Peer Review of Hydrogeological Studies Conducted in Support of the Proposed Rockfort Quarry

Ken W. F. Howard MSc, PhD, PHG, PGeo, CGeol FGS
University Professor and Groundwater Consultant

November 21st, 2008

Ref: 20081/1/Caledon

Figure 1. Figure 6.1 of the CBSes Part A: Characterisation Report [3] depicts Conestoga Rovers and Associates' (CRA's) conceptual model of the aquifer system.

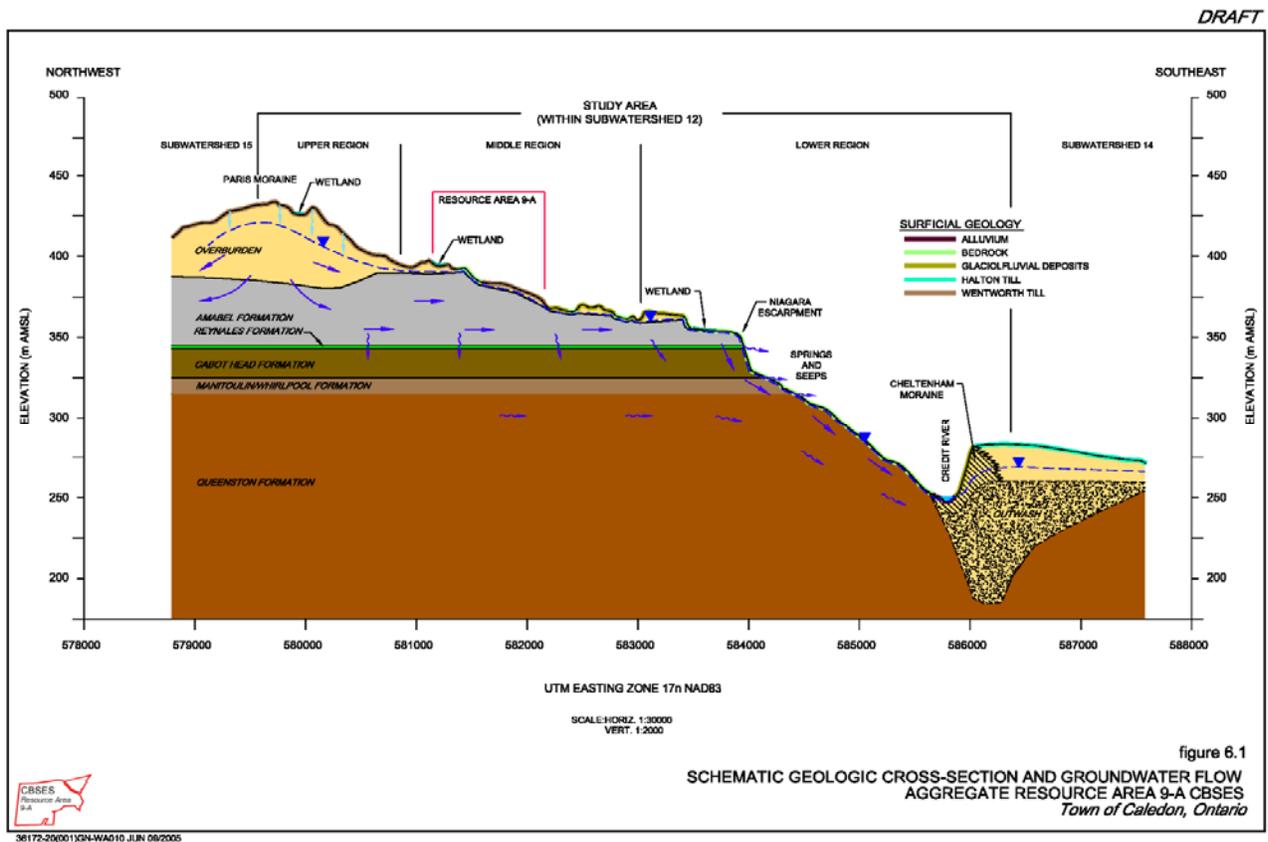
CRA's conceptual model for the study area is illustrated in Figure 1. The model is not explicitly described in CRA reports but, on the basis of the steady state, "equivalent porous medium" numerical models selected for aquifer simulation, their conceptual model clearly ignores critically important hydrogeological features of the study area such as preferential flow via fractures and the role of aquifer storage. I raise this issue because data for the site and for hydrogeologically comparable areas in southern Ontario support a conceptual model that is strongly founded on the principle of "fracture flow" through a complex network of rock discontinuities, locally enlarged by chemical dissolution [24, 25, 26, 27, 28]. This conceptual model sits in stark contrast to that adopted by CRA, but is well endorsed by pumping test results and by the highly sensitive and temporal, hydrologic response of study area springs to changes in aquifer water level. The model is illustrated in Figure 3. It includes laterally extensive fractures that individually support the area's numerous discrete springs and intermittently-isolated ponds.

Figure 4. Model head calibration statistics from about 340 masl to 410 masl (the expected range for the Amabel Formation in the vicinity of the Resource Area) (extracted from AquaResource Inc. ([2], Figure 28)).

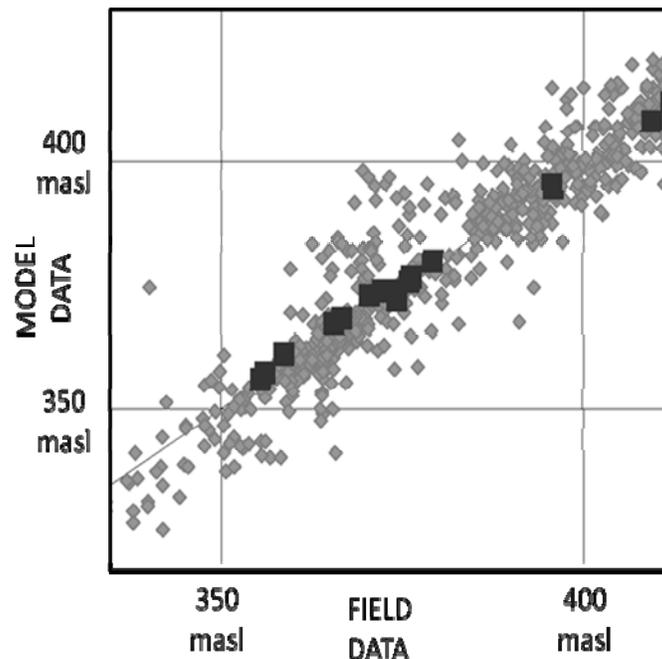
- Attempts were made to calibrate the model with respect to both heads (water levels) and stream flows. However, the quality of the calibration is poor and inadequate. Model head calibration statistics between about 340 masl and 410 masl (the expected range for the Amabel Formation in the vicinity of the Resource Area) are shown in Figure 4. They show a considerable scatter which exceeds normal levels of tolerance by any “rule of thumb”. In some cases, model heads and field heads differ by 20 m or more. The severity of the problem becomes worse for data within and beneath the Paris Moraine (Figures 5 and 6). Here the statistical scatter becomes more pronounced and the model appears to consistently overestimate heads in the CBSES target wells (denoted by the black squares) by several metres. Given the very high sensitivity of study area stream flows to potentiometric head, the quality of calibration is unacceptable, especially for a model that is being used to investigate and evaluate the sensitivity of water features and functions to changes in land use. The model exhibits similar calibration problems with respect to stream flows. A steady state model calibrated using mean annual values of aquifer recharge should reproduce mean annual stream flows within $\pm 20\%$. No such comparisons are provided. As shown in Figure 7, the model is merely capable of generating flows that are found within the second and third quartile of stream flow observations. Even then, the success rate is approximately two out of every three. Calibration targets that are based on quartiles are too broad in scale, especially given that stream flows often vary annually over several orders of magnitude. Compliance with more rigorous targets is required for a model used to investigate and evaluate the sensitivity of water features and functions to changes in land use.
